**Addendum No. 2
January 20, 2023**

Project: Baltic High School Addition
Baltic, South Dakota
Arch Project No. 2957

Architect: Architecture Incorporated

FIRST FLOOR PLAN - AREA G

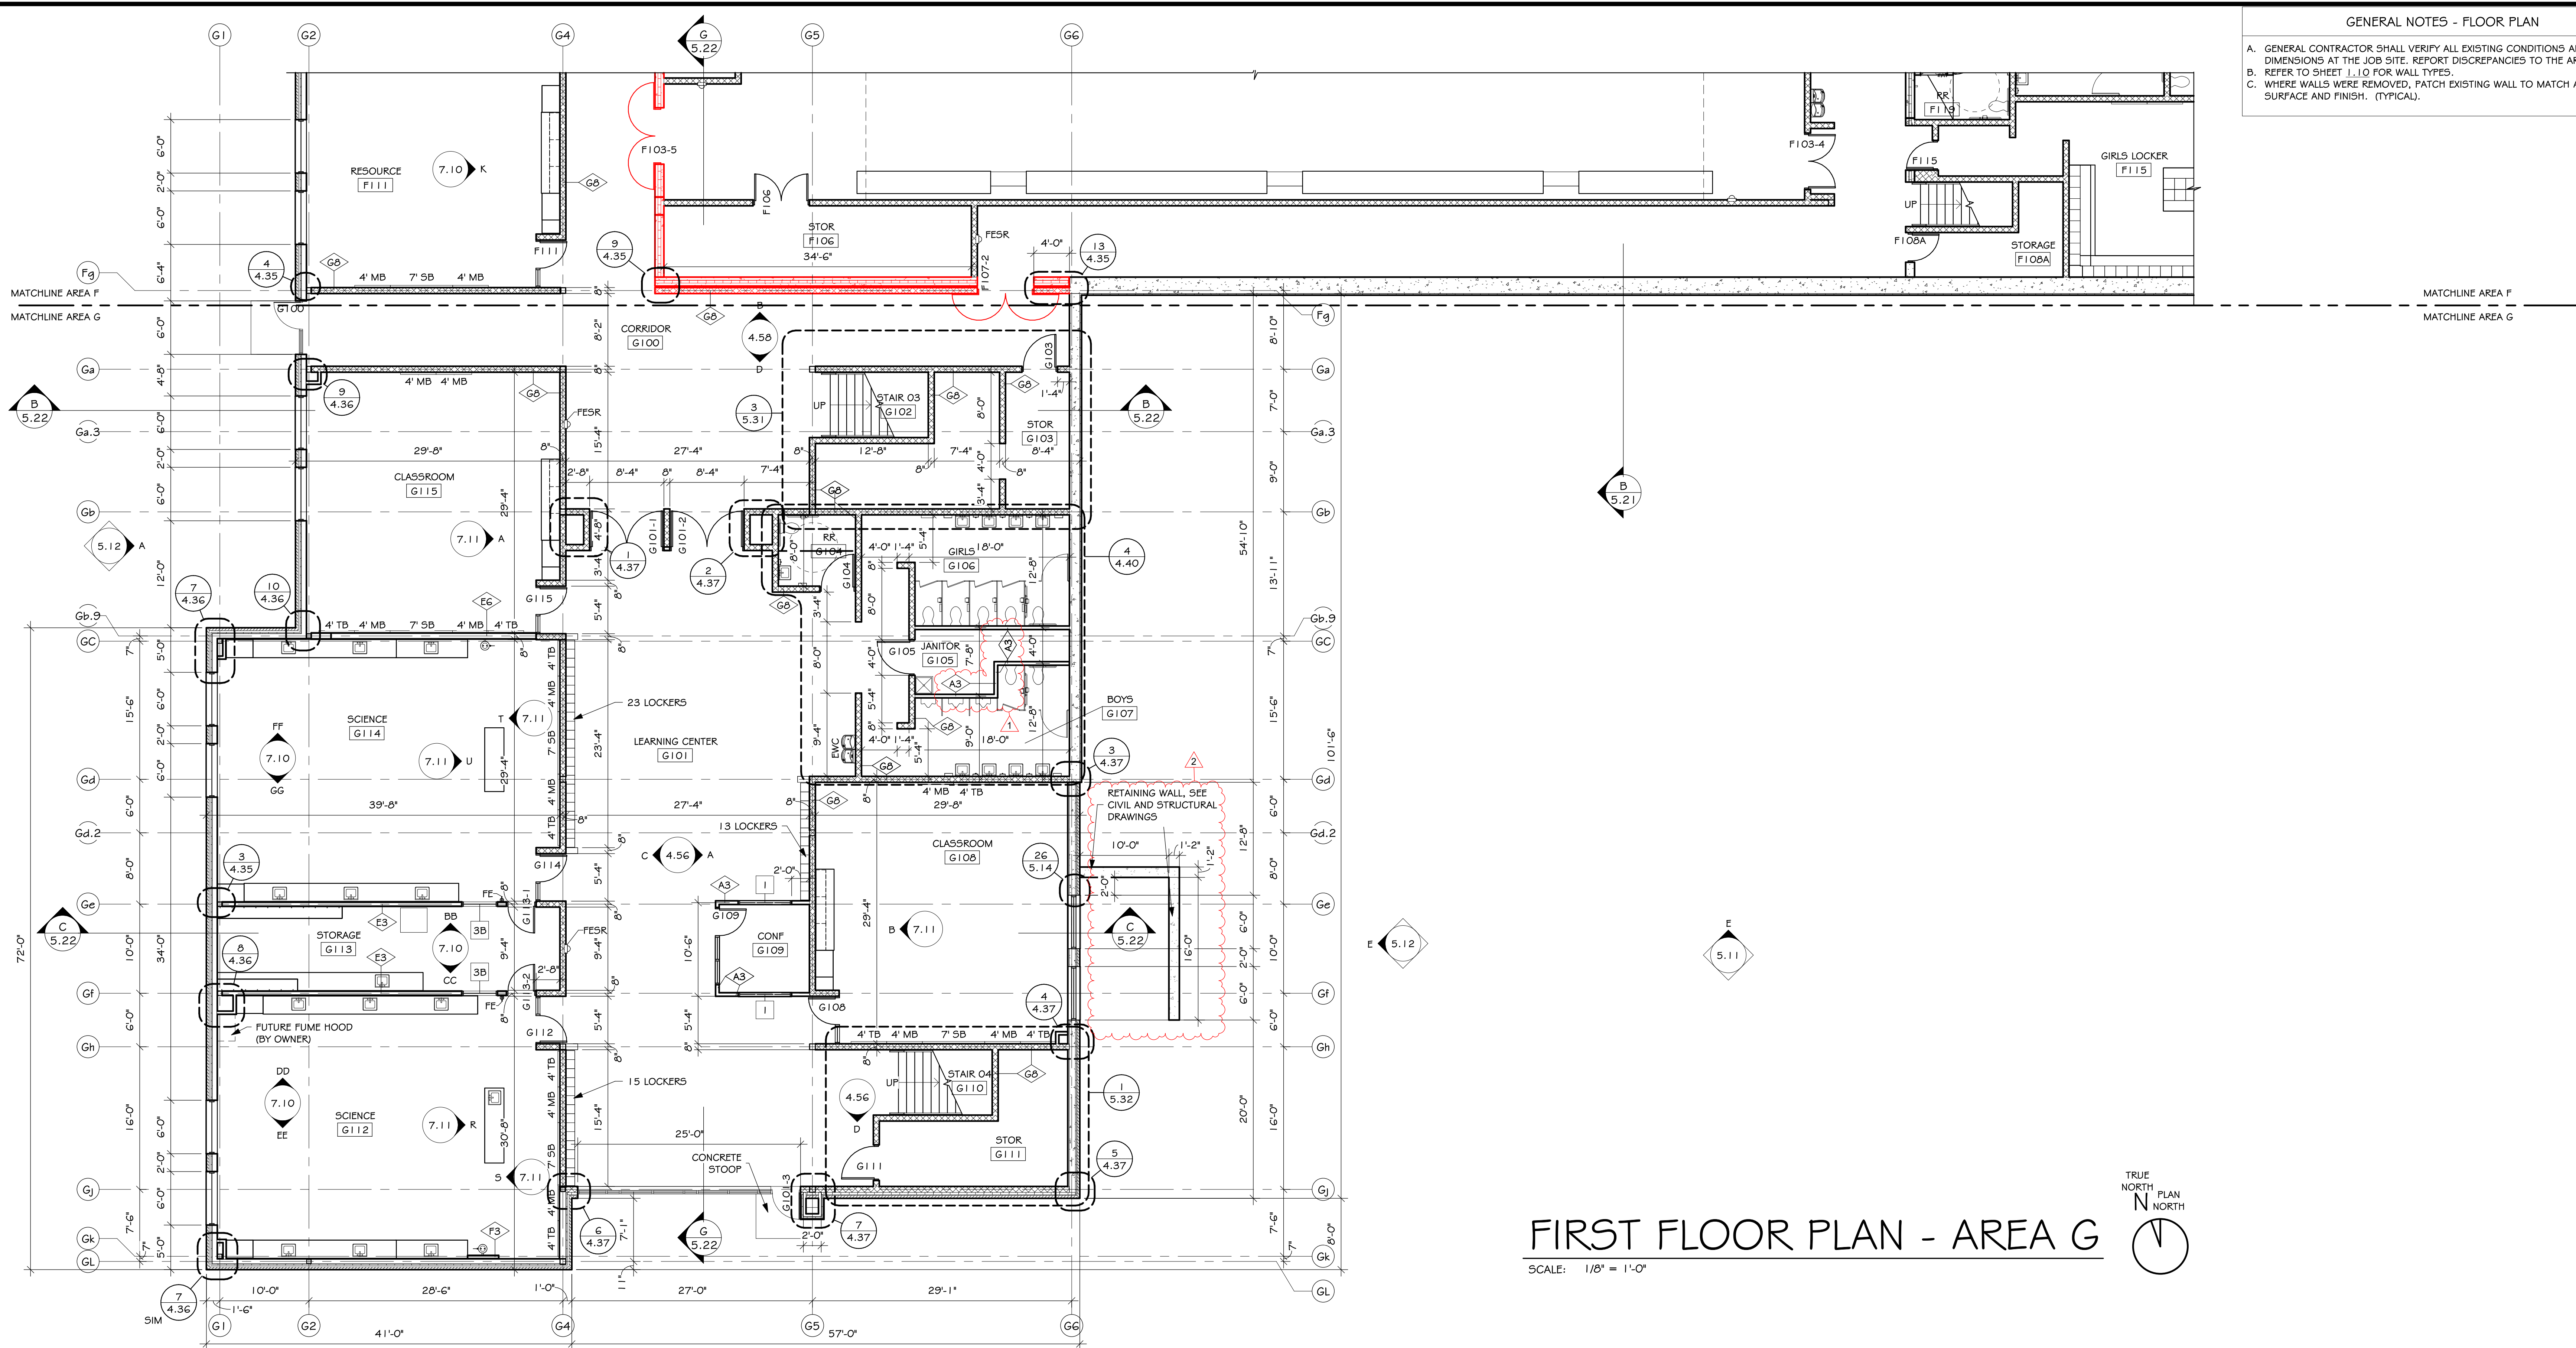
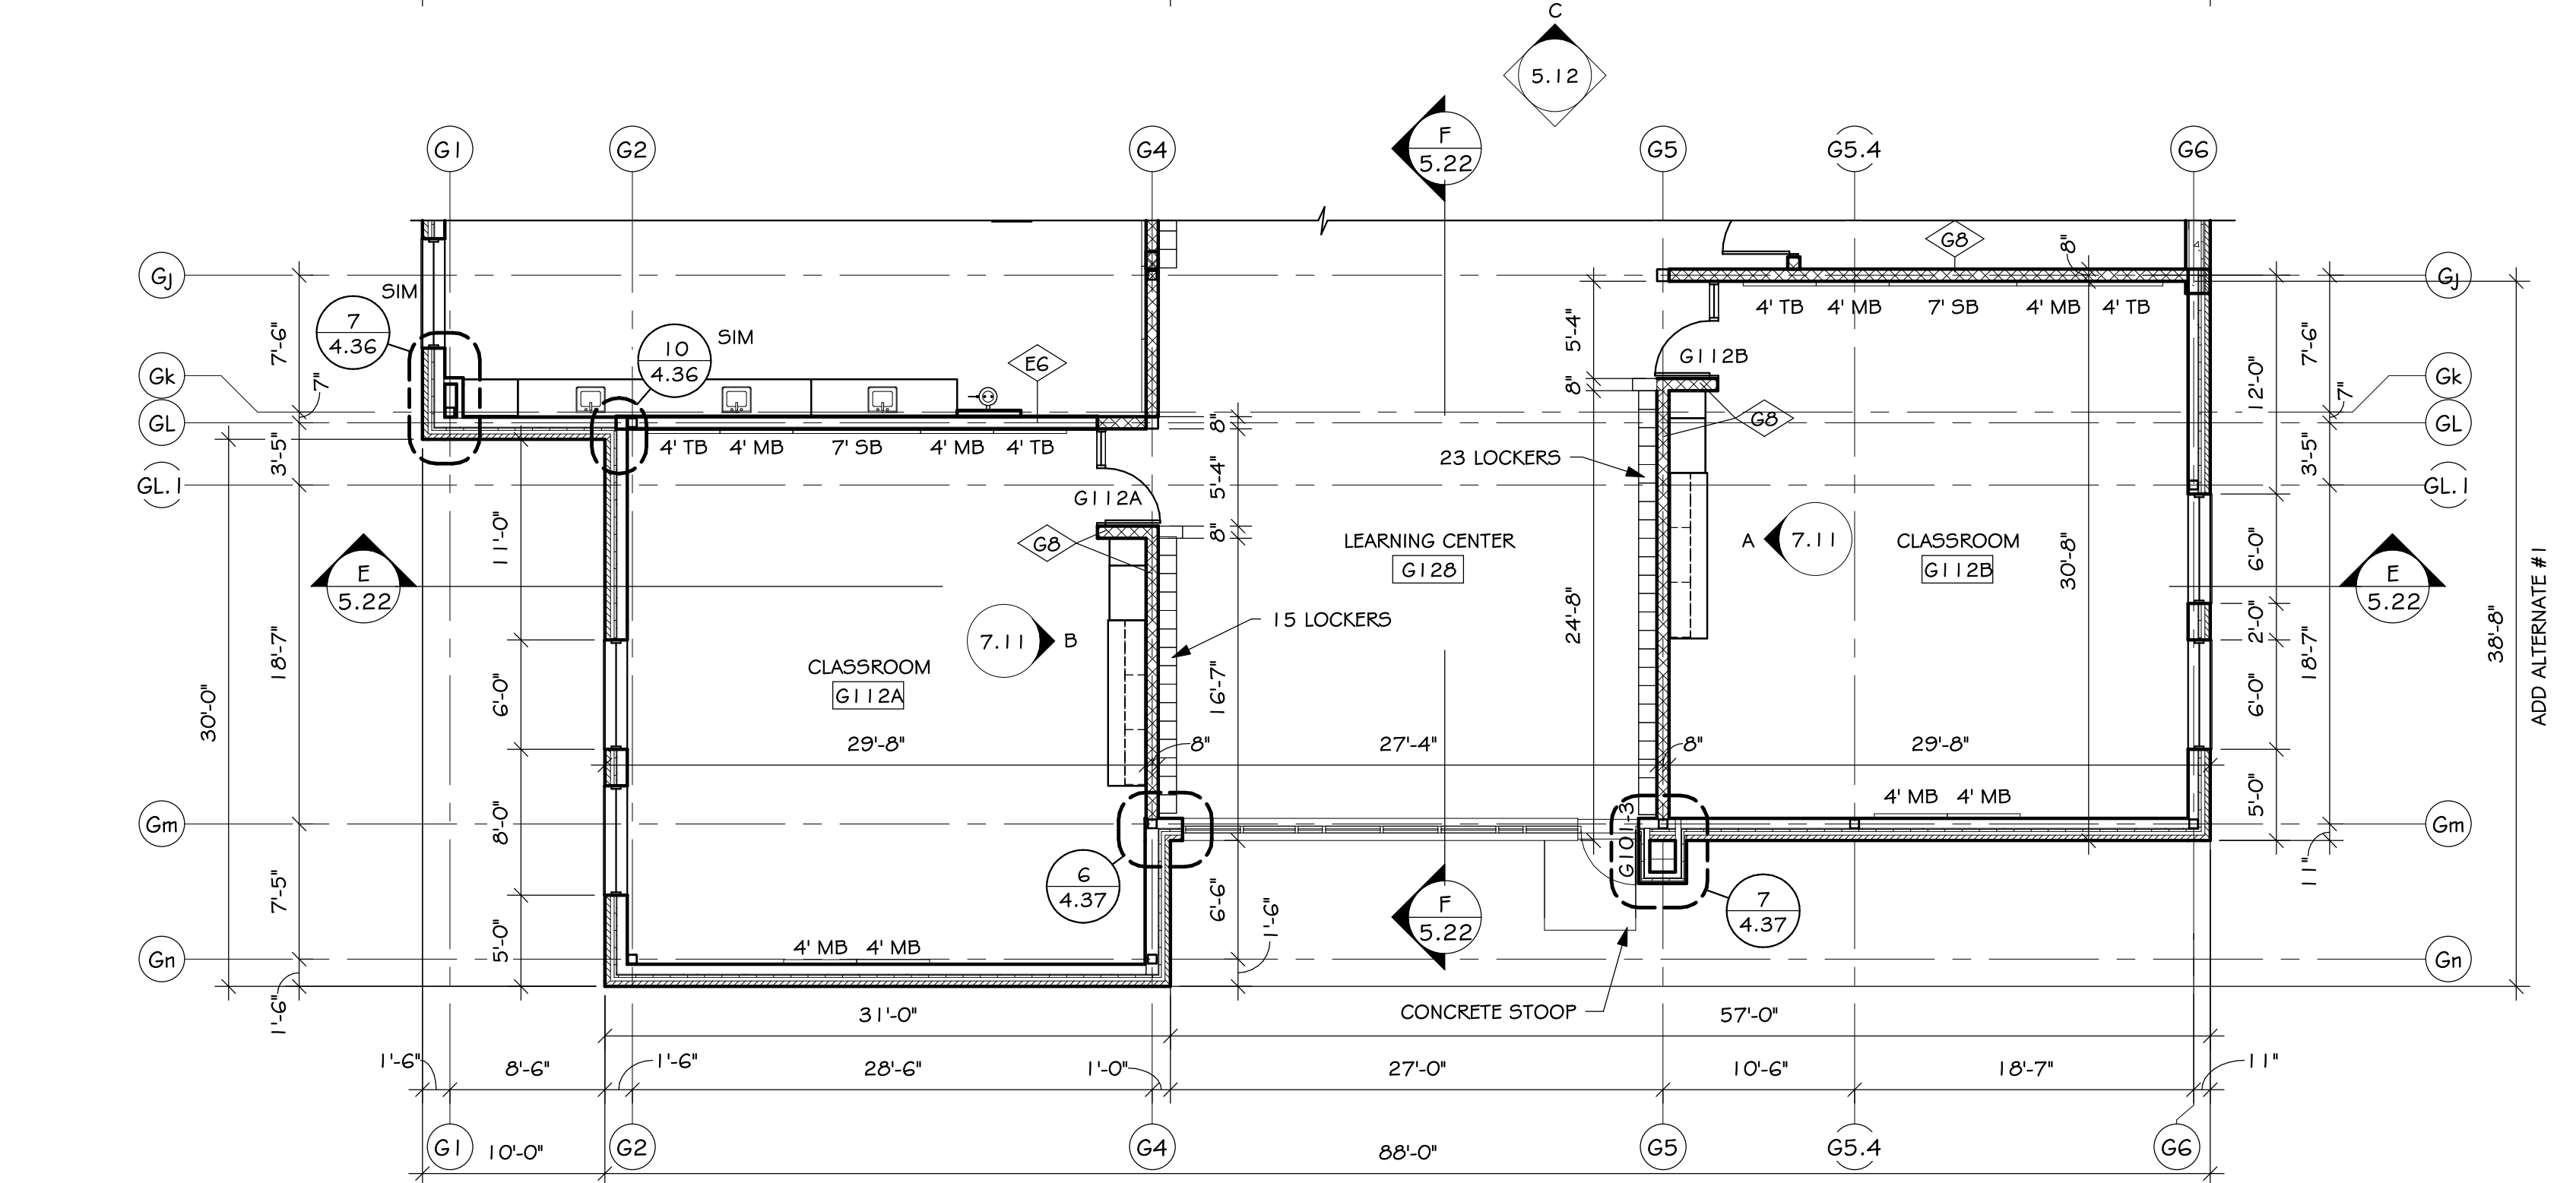
- a) The cast-in-place concrete retaining wall that occurs immediately east of Classroom G108 shall be located where shown per *revised* Sheet 4.10-1G, dated 1-20-23, which is attached to the end of this addendum.
 - i) Refer to civil and structural drawings for additional information.
 - (1) NOTE: The dimensions and location of this cast-in-place retaining wall shown on *revised* Sheet 4.10-1G shall govern if there are discrepancies between *revised* Sheet 4.10-1G and civil / structural drawing Sheets.
 - ii) The exposed vertical faces of this cast-in-place retaining wall shall be left “aesthetically pleasing”.

FIRST FLOOR PLAN - AREA H

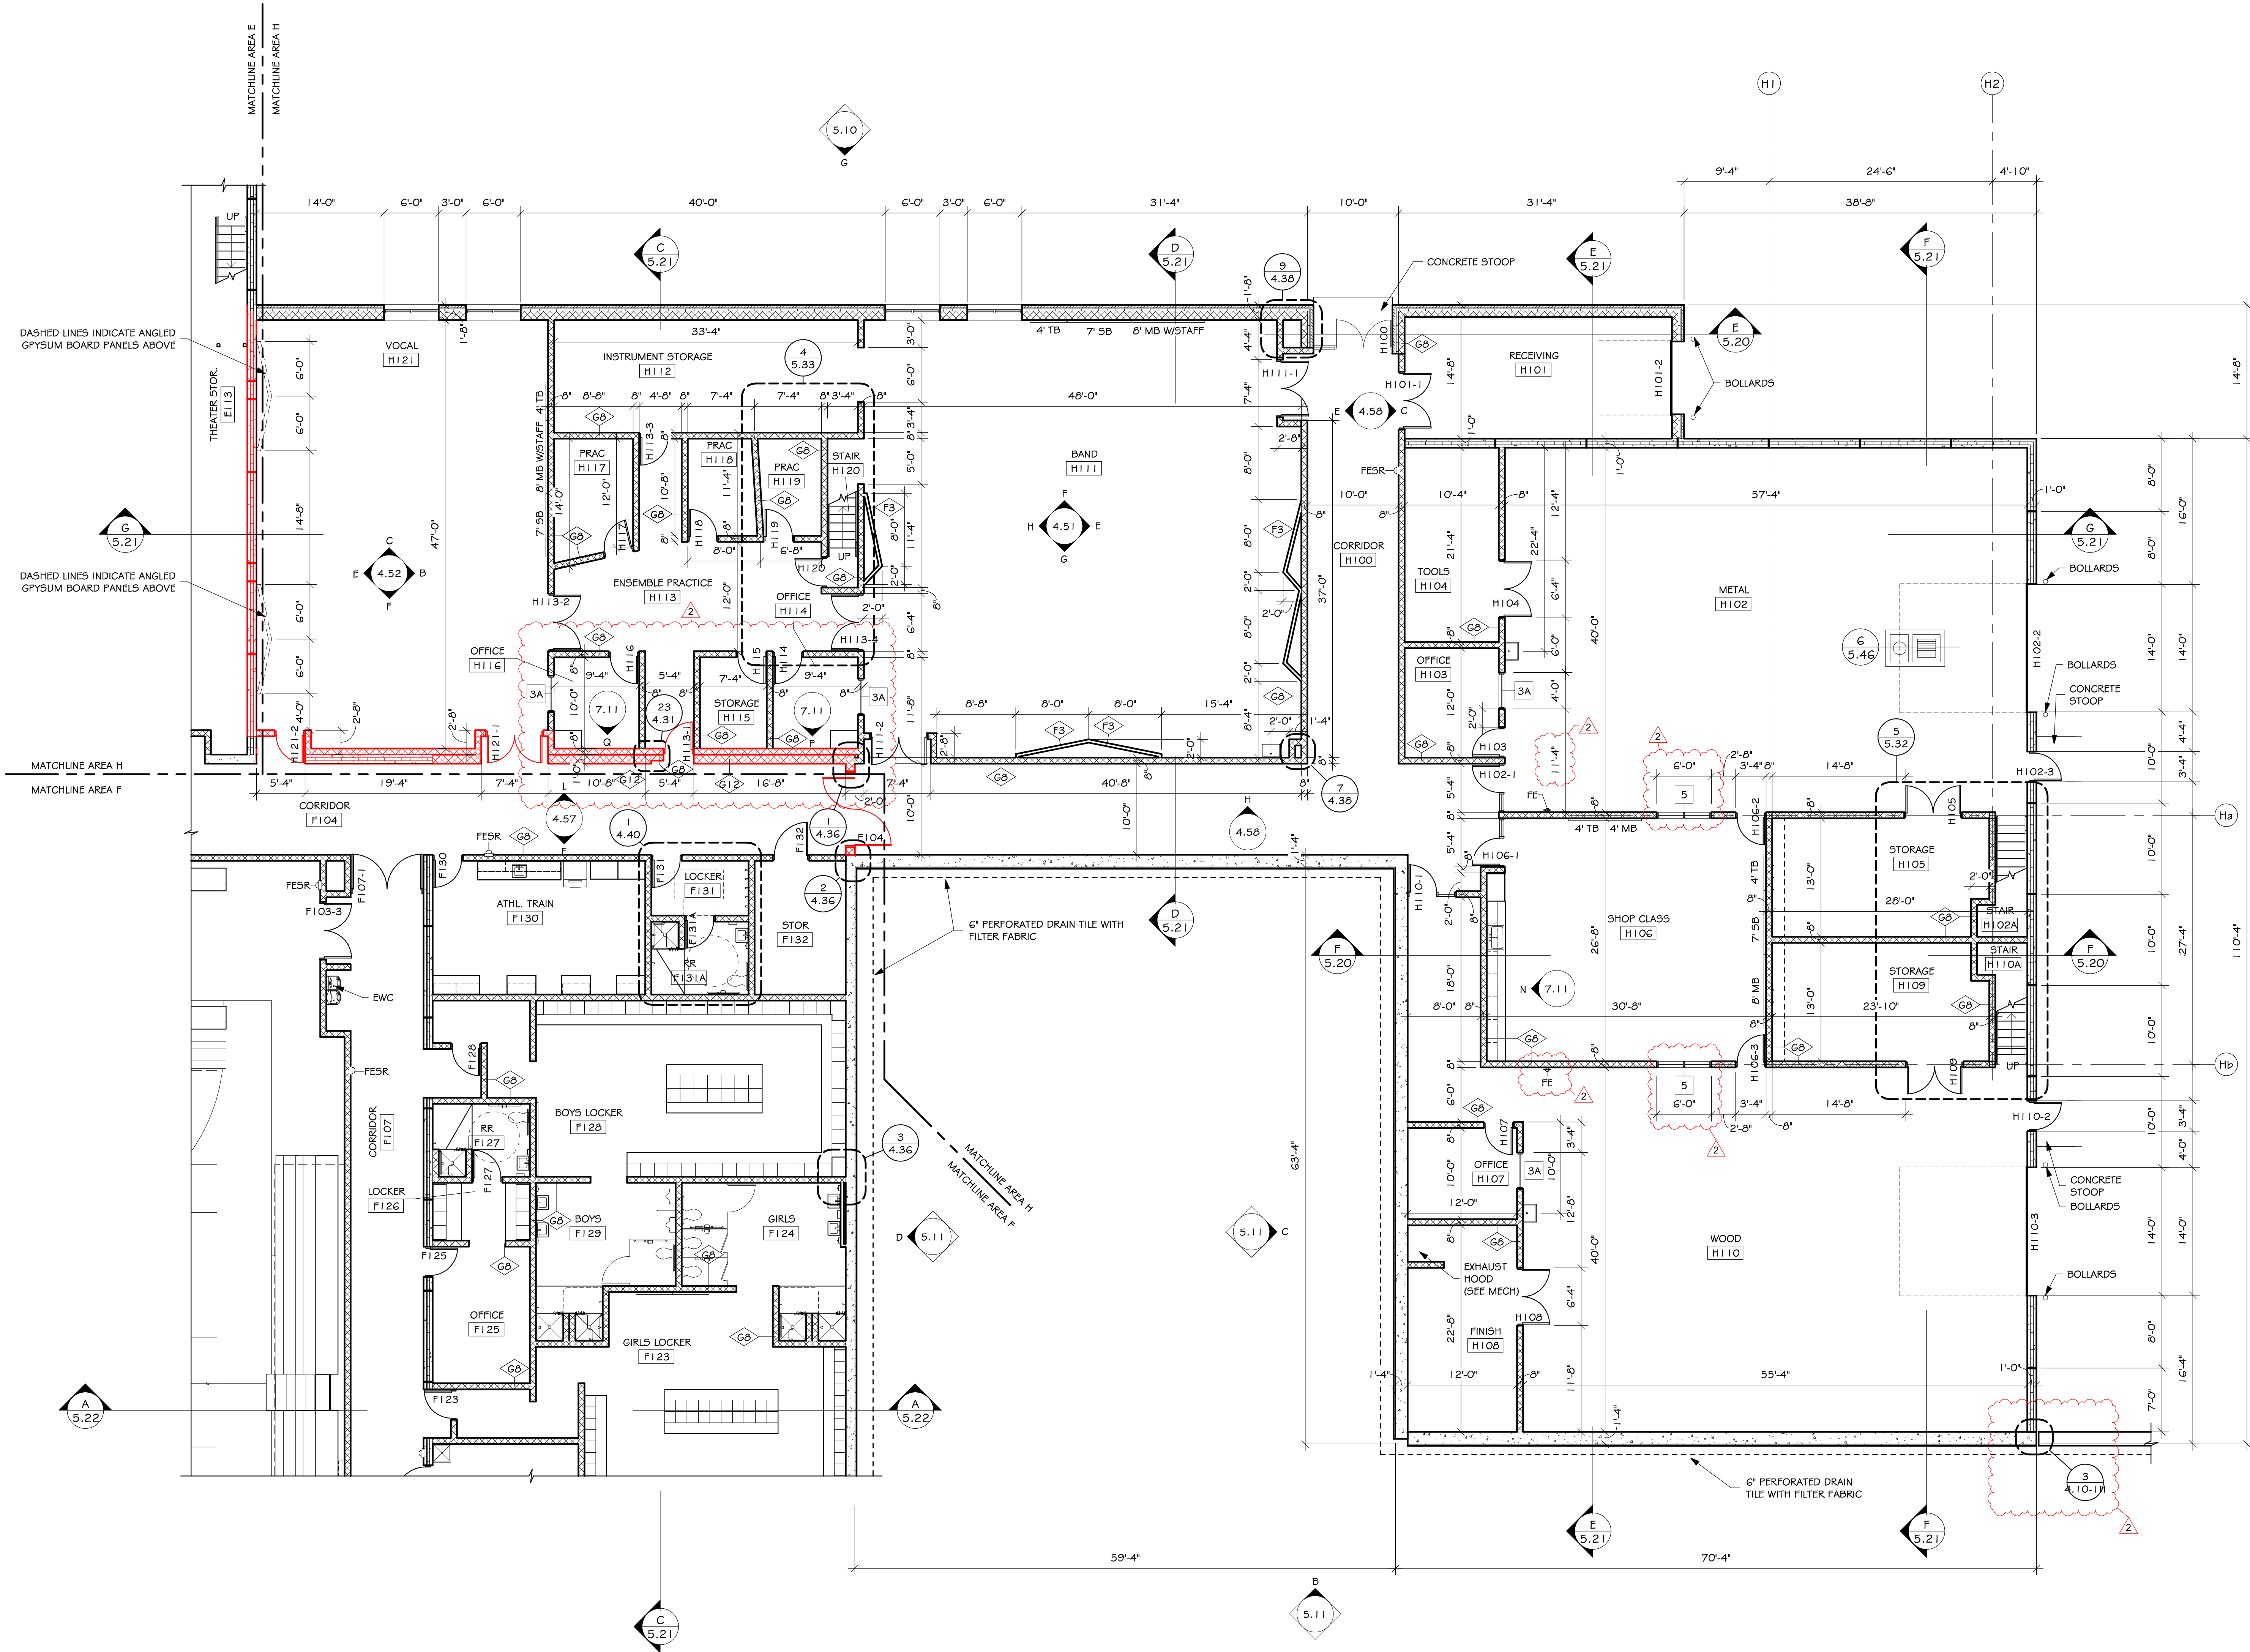
- a) Provide 6’-0” wide borrowed lites in the north and south walls of SHOP CLASS H106 in lieu of the 4’-0” wide borrowed lites originally shown.
 - i) Reference *revised* drawing Sheet 4.10 H (attached to the end of this addendum) for borrowed lite locations.
 - ii) See *revised* drawing Sheet 4.31 for the elevation of newly added borrowed lite TYPE 5.

- b) Relocate the Type 3A borrowed lite in the east wall of OFFICE H103; shift BL 8 inches to the north. Reference *revised* drawing Sheet 4.10-1H (attached to the end of this addendum) for additional information.

- c) Provide a surface-mounted fire extinguisher on the north wall of WOOD H110 as indicated per *revised* drawing Sheet 4.10-H (attached to the end of this addendum).

- d) The room dimensions of rooms OFFICE H116, STORAGE H115 and OFFICE H114 have been modified. See *revised* drawing Sheet 4.10-H (attached to the end of this addendum) for revised dimensions.

- e) Revise jamb on the latch side of the door H113-1; refer to *revised* Sheets 4.10-H and 4.31 for *revised* jamb detail 23/4.31 (attached to the end of this addendum) for additional information.

- f) See newly added plan detail 3 / 4.10-1H on revised Sheet 4.10-1H for detail / clarification at the intersection of the segmented retaining wall and the southeast corner of the building in Area G (Wood H110).
